Response to Requests for Additional Information for the Review of the ARCADIA[®] Reactor Analysis System for PWRs Methodology Description and Benchmarking Results Topical Report

ANP-10297Q1NP
Revision 0

AREVA NP Inc.

Figure 45-A-1: AO Comparisons

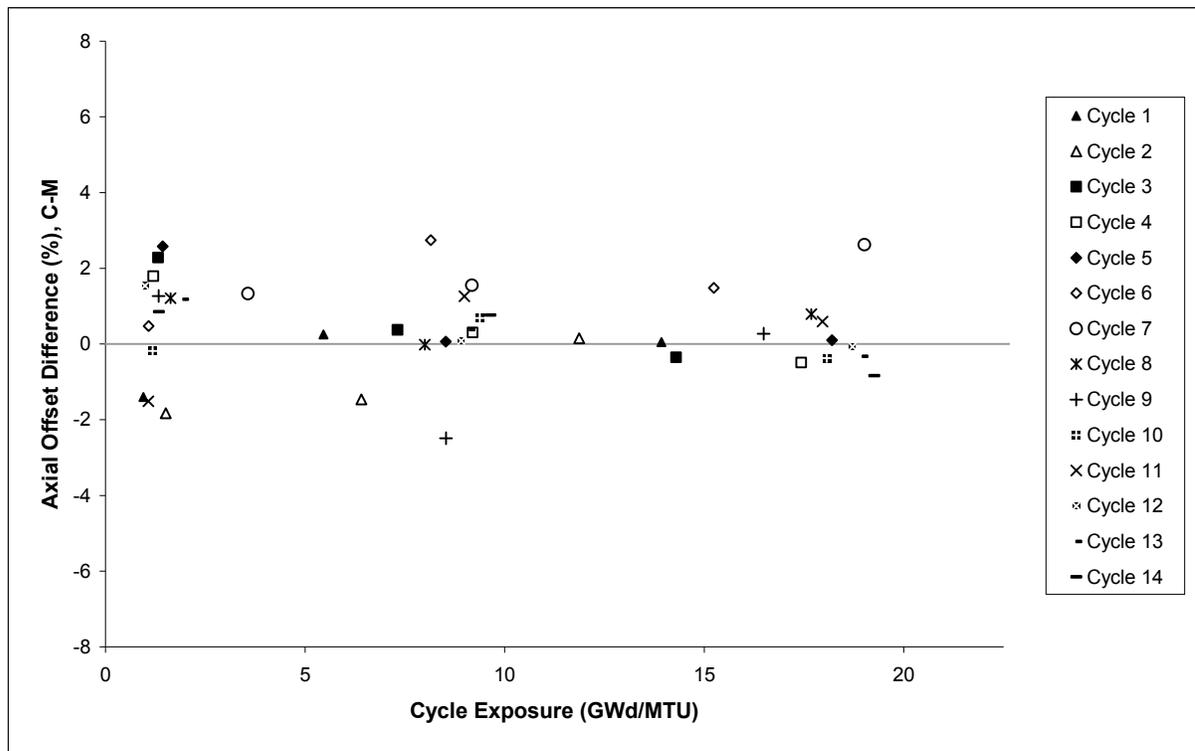
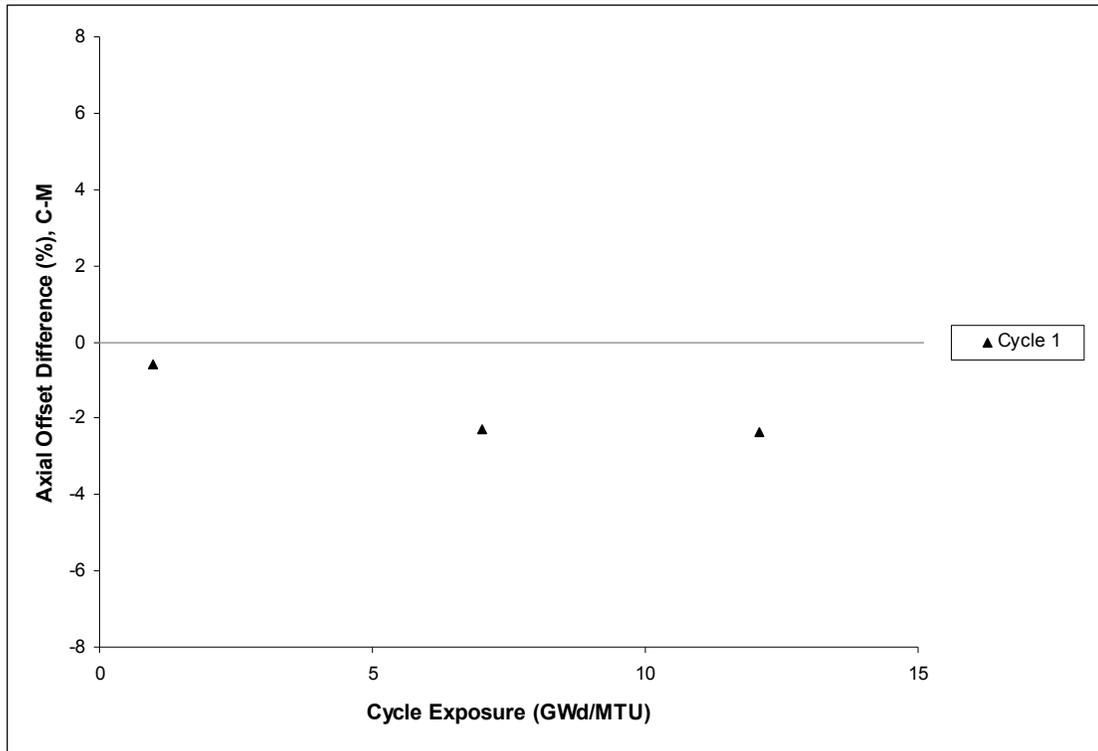
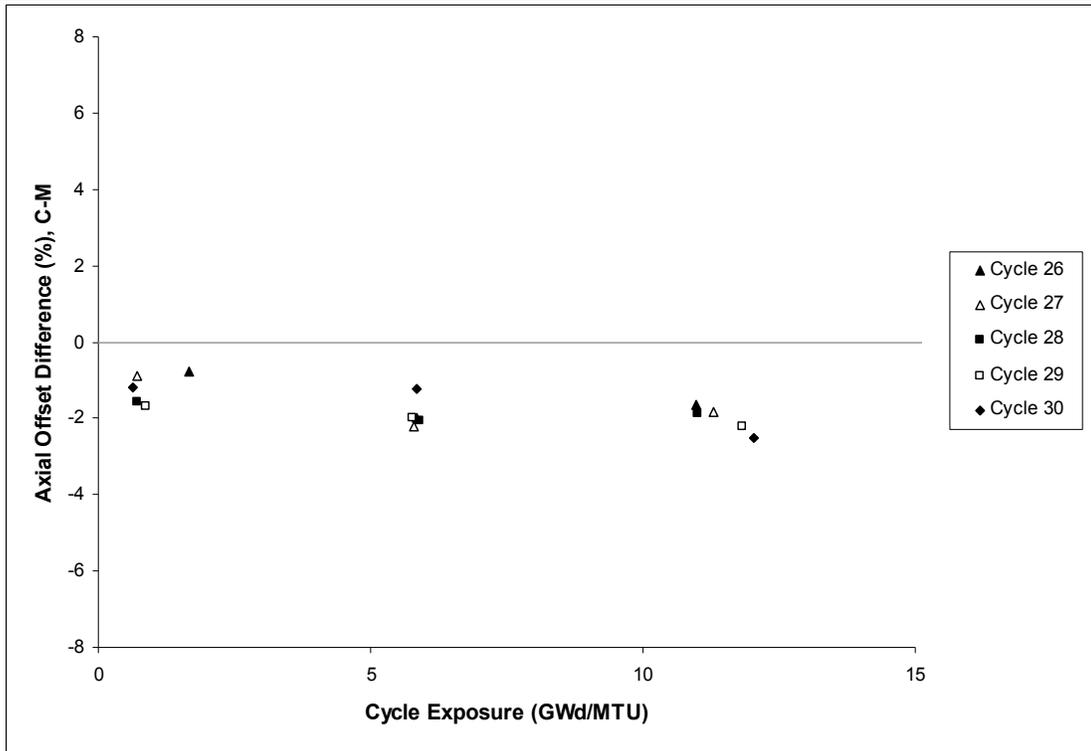
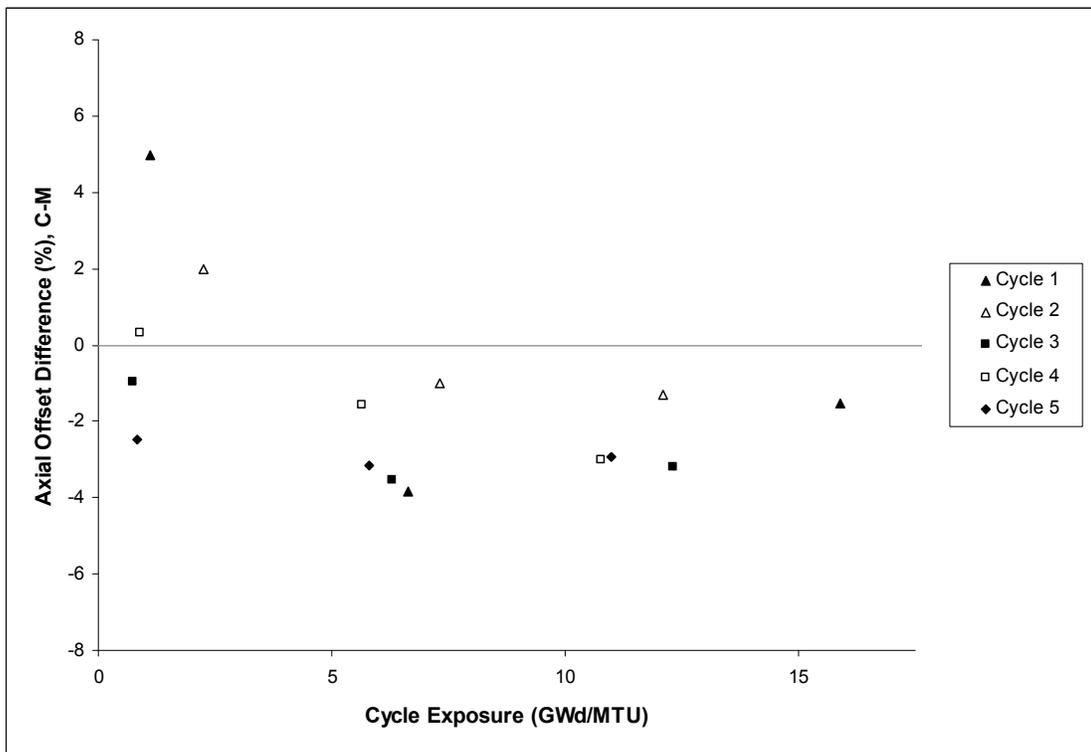
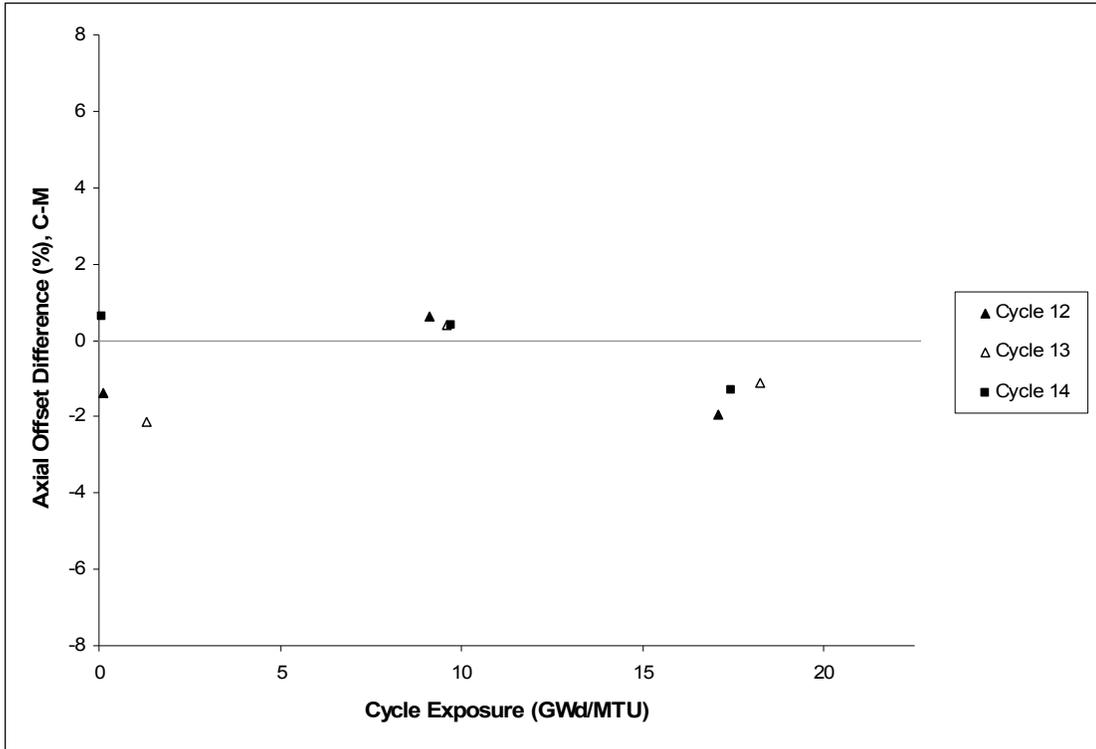
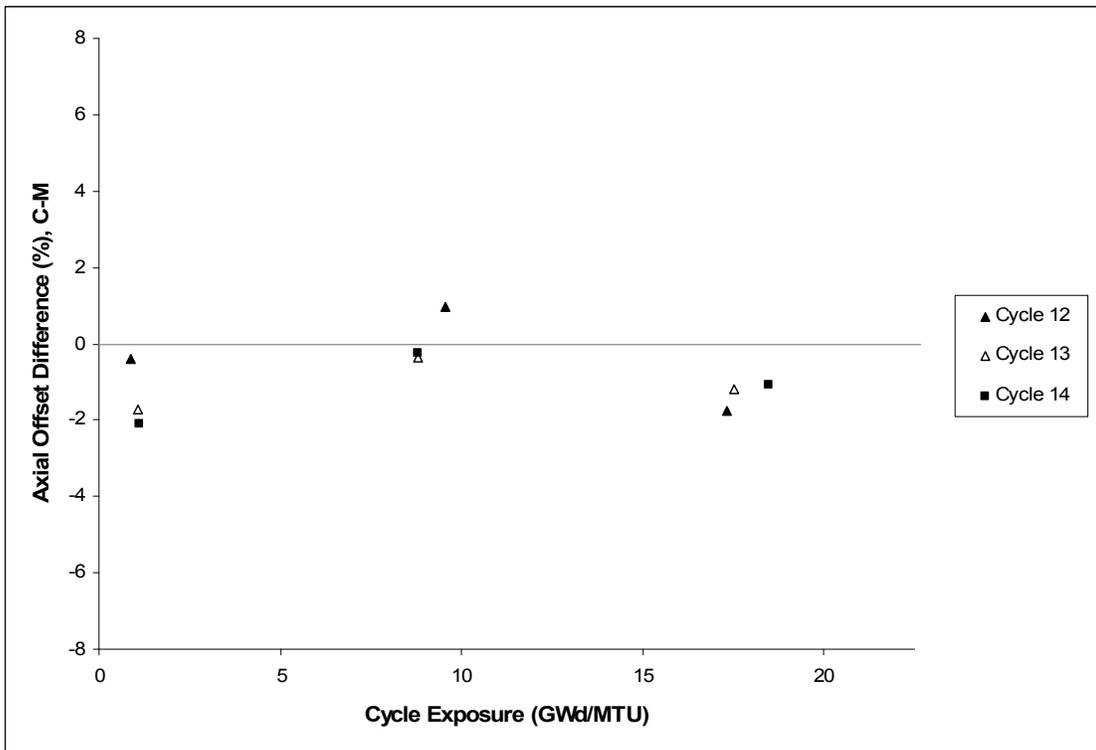
RAI 45 A summary plot of the difference between calculated and measured axial offset, by cycle, would be beneficial. This may help to discern if the core average axial shape is contributing to the peak assembly power deviations.

Summary plots showing the calculated to measured AO differences at the points in cycle that are consistent with the core average power maps. This was done so that the measured AO values are consistent with the predicted values. The plots of showing the AO differences are given below:
